UNITED STATES PATENT AND TRADEMARK OFFICE

APPLICATION NO.	FILING DATE	FIRST NAMED INVENTOR	ATTORNEY DOCKET NO.	CONFIRMATION NO.
10/072,106	02/08/2002	John Walter Turgeon-Schramm	3616.199US01	2539
7590	11/05/2003		EXAMINER	
MERCHANT & GOULD P.C. P.O. Box 2903 Minneapolis, MN 55402-0903			CHAN, KO HUNG	
			ART UNIT	PAPER NUMBER
			3632

DETAILED ACTION

Examiner's illustration

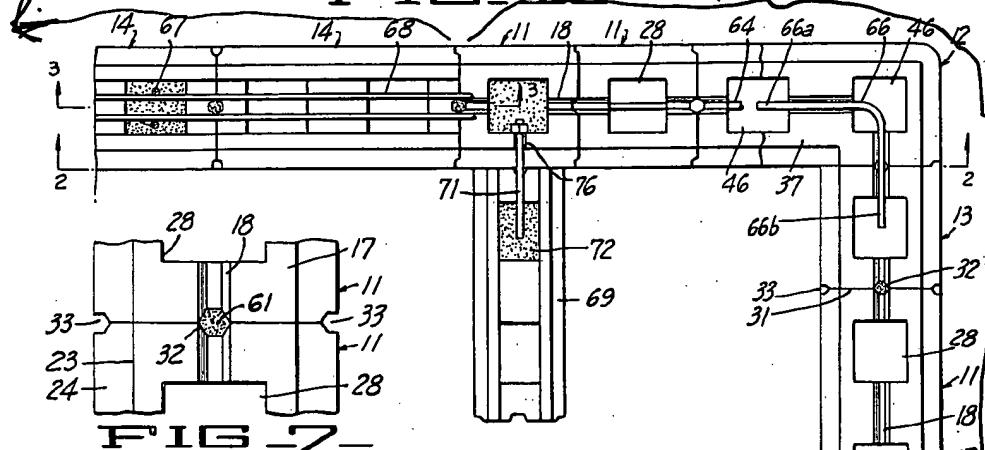
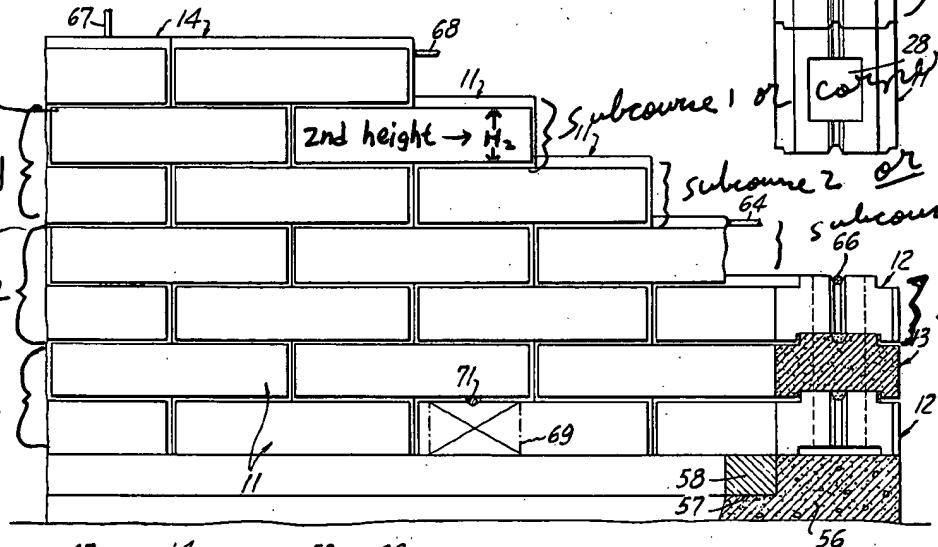
Claims 6-10,12, and 14 are rejected under 35 U.S.C. 102(b) as being anticipated by Frantz (US patent no. 2,944,162). Franz discloses a wall (fig. 1) having plurality of courses (see attached examiner's illustration of courses 1, 2, 3 for example where each course is defined by two rows of blocks), each course having a plurality of blocks (12) defining an exterior corner (12) and a second plurality of blocks (see attached

illustration) forming a wall portion adjacent the exterior corner, each block of first and second plurality of blocks include a channel (18) formed on a top surface thereof, a retaining bar (66) disposed within the channels in both the first and second plurality of blocks; wherein the channels of first and second plurality of blocks are aligned wherein the blocks in each subcourse (defined by a single row of blocks) have a height less than the height of the first plurality of blocks and the subcourses that form each course at the exterior corner have a combined height that is equal to first height.

blocks forming wall portion

1st height
